Access Compliance Report

Public Rights-of-Way

Intersection ID: 12073	Main Street: E_11TH_ST	Cross Street: N_CALDWELL_ST	Location: N
ADA ID: 46DBE2836517	Ramp Type: PerpDiag	Initial Pass/Fail: Fail	Overall Compliance: No
			Severity Score: 21.25

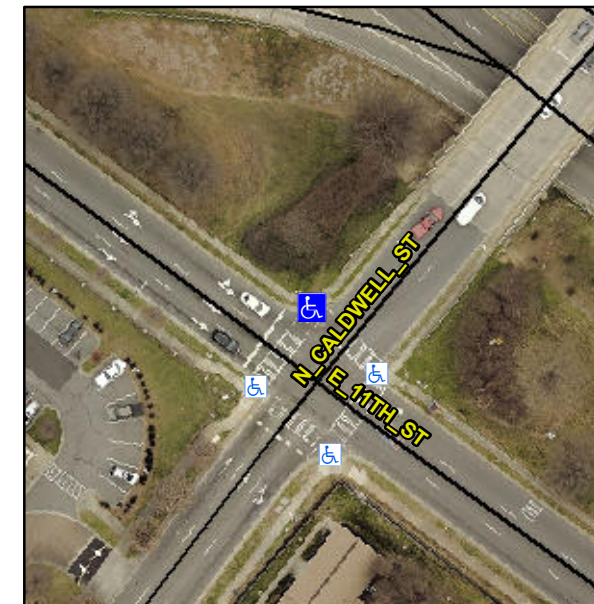
Not Found, R304.5.1, R304.2.2

Compliance	Description	Data	Compliance	Description	Data
N/A	Ramp Length (in)	84.0	No	Ramp Slope (%)	9.7
No	Ramp Width (in)	38.0	Yes	Ramp XSlope (%)	0.3
N/A	Flare Type LT	N/A	N/A	Flare Type RT	N/A
N/A	Flare Slope LT (%)	N/A	N/A	Flare Slope RT (%)	N/A
N/A	Flare Traversable LT?	N/A	N/A	Flare Traversable RT?	N/A
N/A	Landing Length (in)	N/A	N/A	DWS Provided?	N/A
N/A	Landing Width (in)	N/A	N/A	DWS Contrast?	N/A
N/A	Landing Slope (%)	N/A	N/A	DWS Length (in)	N/A
N/A	Landing X Slope (%)	N/A	N/A	DWS Full Width?	N/A
N/A	Landing Curb? (Y/N)	N/A	N/A	DWS Offset (in)	N/A
N/A	Shared Landing?	N/A			
N/A	Gutter Ponding?	N/A	N/A	Gutter Slope (%)	N/A
N/A	Gutter Lip Ht (in)	N/A	N/A	Gutter X Slope (%)	N/A
N/A	Painted X Walk1?	Yes	N/A	Painted X Walk2?	Yes
	X Walk 1 Direction	To SW		X Walk 2 Direction	To SE
N/A	X Walk 1 Width (in)	111.0	N/A	X Walk 2 Width (in)	100.0
	X Walk 1 Slope (%)	2.7		X Walk 2 Slope (%)	3.6
	X Walk 1 X Slope (%)	4.0		X Walk 2 X Slope (%)	3.1

Remove & Replace Curb Ramp With Two New Directional Ramps or Equivalent.
